City of Dublin

# Minor Project Review

**14-064MPR – BSC Sawmill Center  
Neighborhood District**

**Dublin Village Center – Partial Demolition**

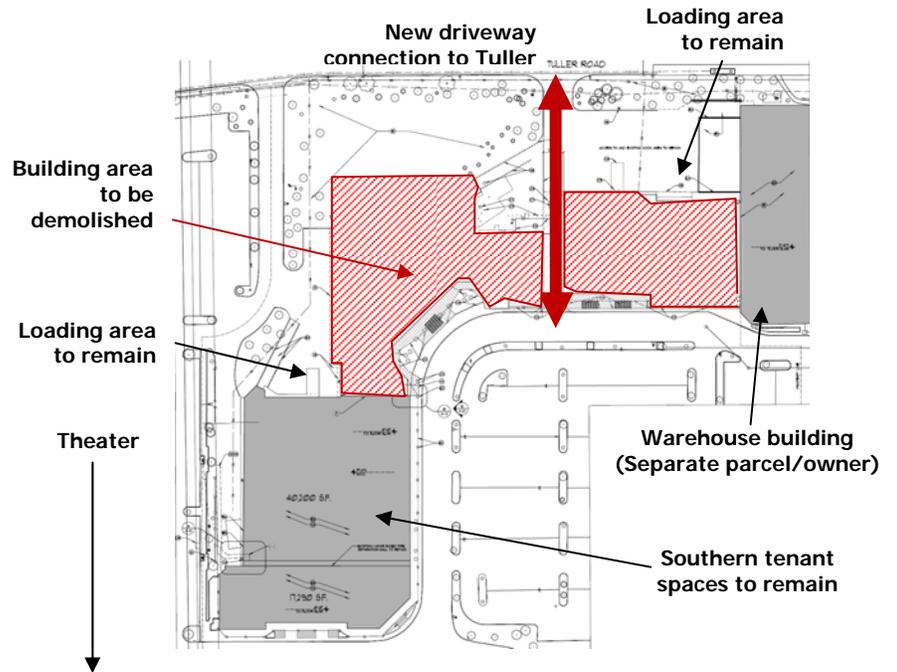
This proposal is to demolish 68,920 square feet of an existing 126,410-square-foot building (57,490 square feet to remain) as part of the northern portion of the Dublin Village Center shopping center. The southernmost tenant spaces (northeast of the existing movie theater) will remain. The large warehouse building at the northeast corner of the site at the curve in Tuller Road, which is on a separate parcel with a different property owner, will also remain. The portions of the building to be removed are highlighted in the image below.

The site area will be restored and seeded as lawn and graded for stormwater management. The applicant is also proposing to connect an existing driveway providing access from Tuller Road to the loading area for the warehouse building south to the parking lot drive aisle in front of the tenant spaces to be demolished.

Given the uncertainty of the timing related to screening the southern loading dock area, the mounding for both areas should be completed at the time of the demolition. The evergreen plantings should also be installed at 10 feet on center, subject to Planning approval, to achieve the minimum 50% year round opacity required by Zoning Code Section 153.065(E)(3)(c)1.C.

- 1) Please note that the water main to the south of this building is a public main.
- 2) As part of the demolition permit, the applicant shall identify a staging and stockpiling area.
- 3) The applicant shall coordinate any changes to the water services with the City of Columbus.
- 4) Although this is a private site improvement, adding a new site drive connection to the south under the demolition permit is questionable, in addition to whether it is even necessary/desirable.

- 1) That the applicant obtain the adjacent property owner's signature and consent on the Certificate of Zoning Plan Approval and demolition permit for the portion of the improvements to the west wall of the warehouse building;
- 2) That the applicant complete the mounding at the time of the demolition and screen the existing southern loading area by October 1, 2015 following the approval of the demolition permit, or when the tenant space is occupied, whichever is sooner, in accordance with this plan;
- 3) That the evergreen plantings be installed at approximately 10 feet on center, subject to Planning approval;
- 4) That the applicant identify a staging and stockpiling area as part of the demolition permit; and
- 5) That the applicant coordinate any changes to the water services with the City of Columbus.
